NOTICE UNDER SECTION 96 OF ACT III OF 1901.

I beg to inform you that I intend building Five two rooms & Bath
stoned on plot No. 11
Survey Sheet No. 4-D-32 situate in Sichay Village Gulamshah
Street, gail Quarter.

Plan Showing Proposed
Additions & Alterations on Plot No II Sheet D-2
Jail Quarter
Scale 1/8"

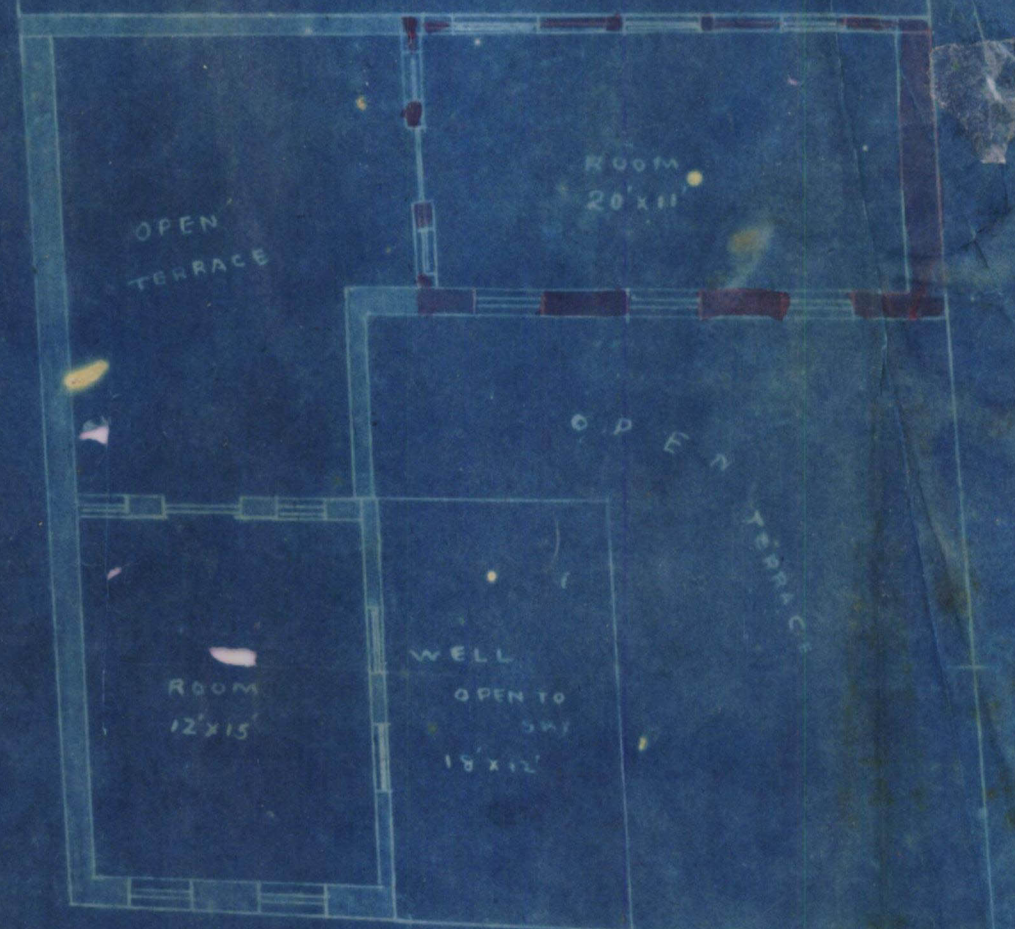
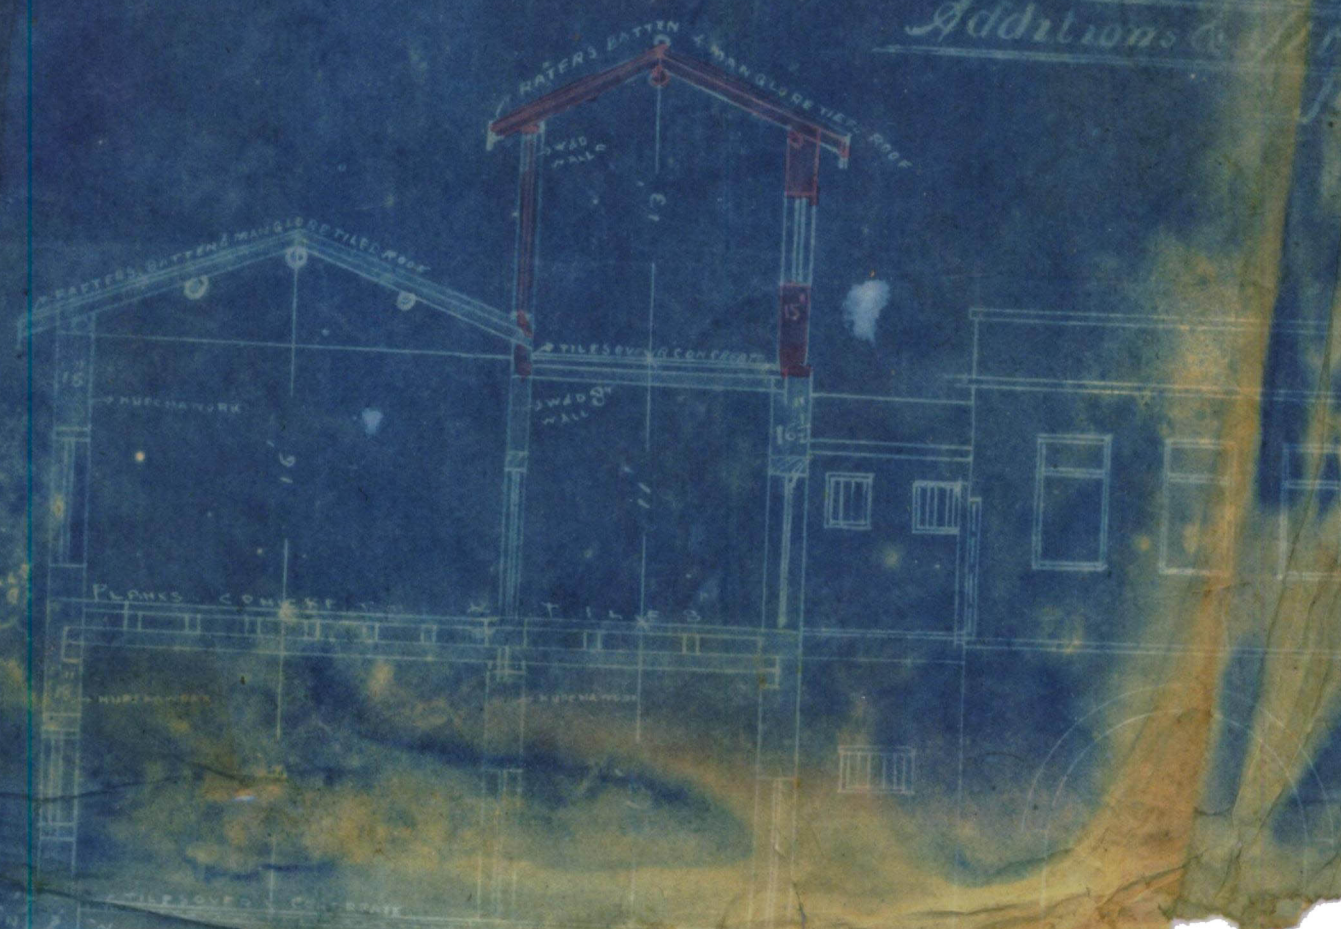
Returned to the Engineer, Karachi Municipality, with the following remarks :— *Permission to build additional rooms cannot be granted, as it will render the building unfit for human habitation.*

They report that the proposed additional rooms
will render ^{existing} building unnecessary as the
same blocks up light ^{as} the building

Remarks Sir, With reference to the they to report
that the additional room will render the
existing building insufficient. permission asked
for cannot be granted. approved

With reference to their application dated 17th April 1918 received on 22nd April 1918 with plan of the proposed additional rooms and the bath rooms to be erected on plot No.11, D-2, Jail Quarter, Messrs Abdulhusain Tyabbhai & Adamali Tyabbhai are informed that the proposed rooms will render the existing building insanitary. The plan therefore cannot be approved and it is returned herewith.

DISAPPROVED
